Area 22 & 23, St Leonards South
26-50 Park Rd, 27-47 Berry Road, 48-54 River Road

RESPONSE TO COUNCIL RFI

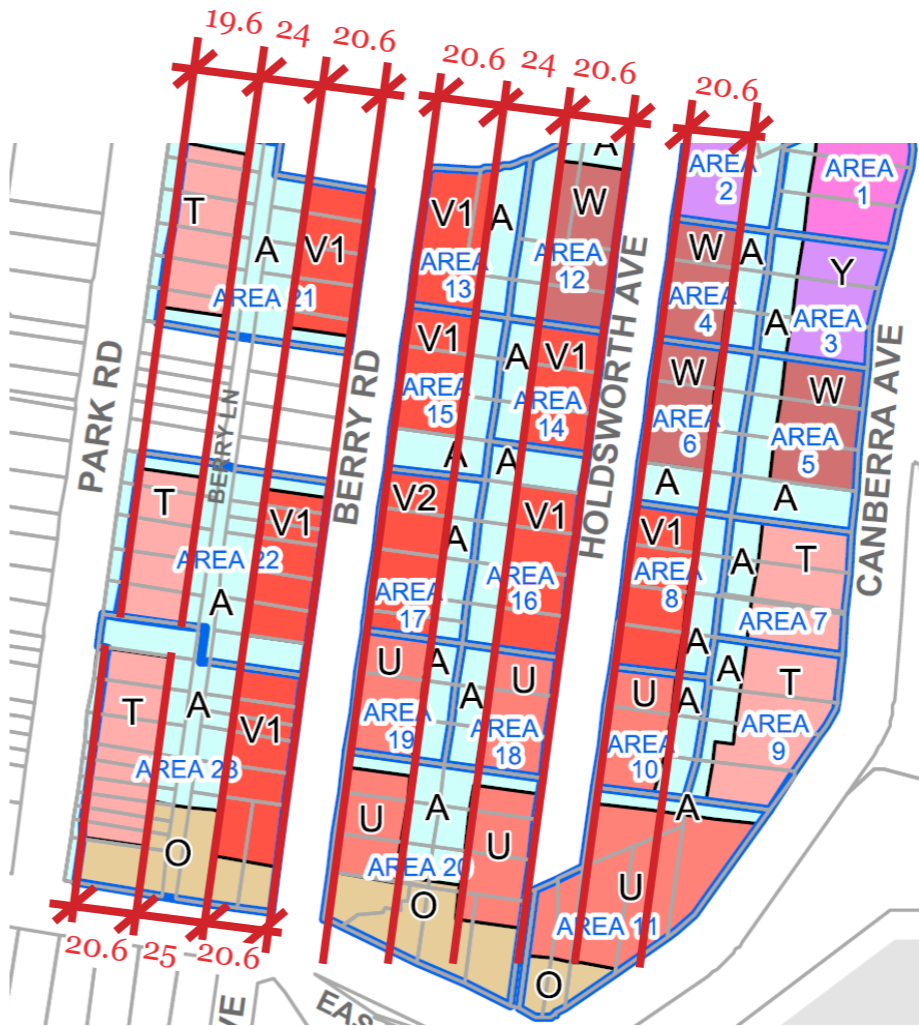
The proposed building setbacks do not comply with the DCP requirements at the following areas:

- Park Road frontage (Building C) 10m setback at level 1, 13m setback at level 3 and 16m setback at level 6 and above

DCP Building from depth control of 18-22m, Area 22 Park Road can only achieve 13.6-19.6m.

Building C GF Part - storey Calculation by Lane Cover Council:

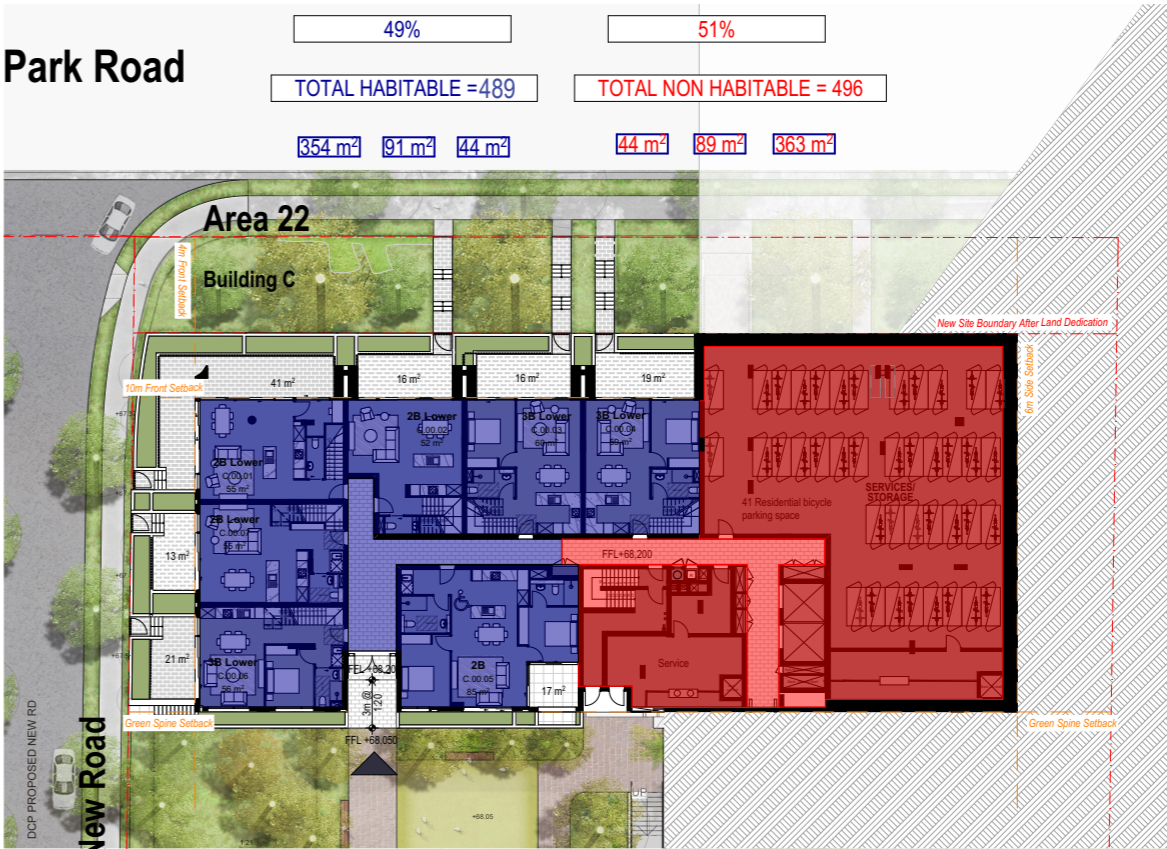
As discussed in the previous RFI letter on 3 March 2023, Council required further information to confirm that the proposed part storeys complied with the definition. Since then, Council has undertaken a desktop calculation and assessment of the proposed part storeys on building C and building D. The calculations confirm that less than 50% of total floor area of the proposed part-storeys are classified as non-habitable space as per the definition in the DCP. Please refer too Annexure A in relation the part storeys.

- Building C Ground floor is only 44.7% non-habitable and does not comply. The floor plan must be re-designed to meet the DCP definition.
- Building D Level 1 is only 46.28% non-habitable and does not comply. The floor plan must be re-designed to meet the DCP definition.

-Habitable Space: 502m² - 55%
-Non-habitable Space: 406m² - 45%

The methodology was agreed in the post-DA meeting dated April 04. As a principle, the area of the corridor shall be divided in half with 50% included as non-habitable area.

-Habitable Space: 489m² - 49%
-Non-habitable Space: 498 m² - 51%

Building D L1 Part - storey Calculation by Lane Cover Council:

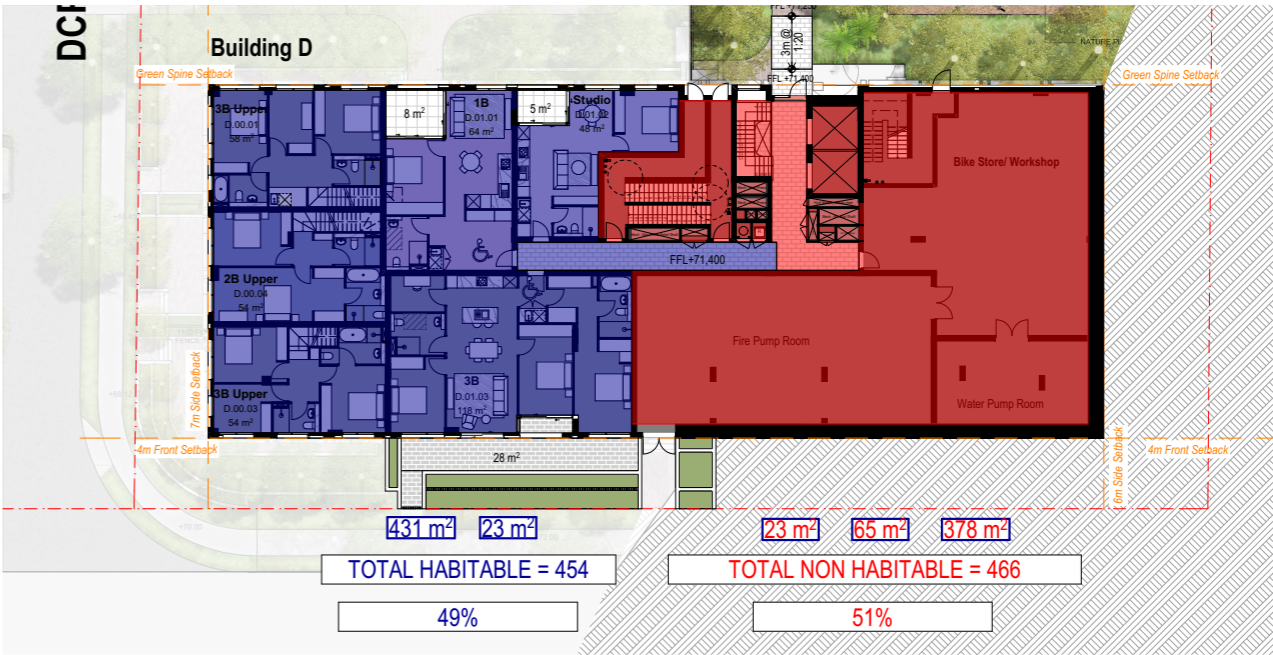
As discussed in the previous RFI letter on 3 March 2023, Council required further information to confirm that the proposed part storeys complied with the definition. Since then, Council has undertaken a desktop calculation and assessment of the proposed part storeys on building C and building D. The calculations confirm that less than 50% of total floor area of the proposed part-storeys are classified as non-habitable space as per the definition in the DCP. Please refer too Annexure A in relation the part storeys.

- The calculations confirm that less than 50% of total floor area of the proposed partstoreys listed below are classified as non-habitable space:
- Building C Ground floor is only 44.7% non-habitable and does not comply. The floor plan must be re-designed to meet the DCP definition.
 - Building D Level 1 is only 46.28% non-habitable and does not comply. The floor plan must be re-designed to meet the DCP definition.

-Habitable Space: 476m² - 54%
-Non-habitable Space: 410m² - 46%

The methodology was agreed in the post-DA meeting dated April 04. As a principle, the area of the corridor shall be divided in half with 50% included as non-habitable area.

-Habitable Space: 454m² - 49%
-Non-habitable Space: 466 m² - 51%
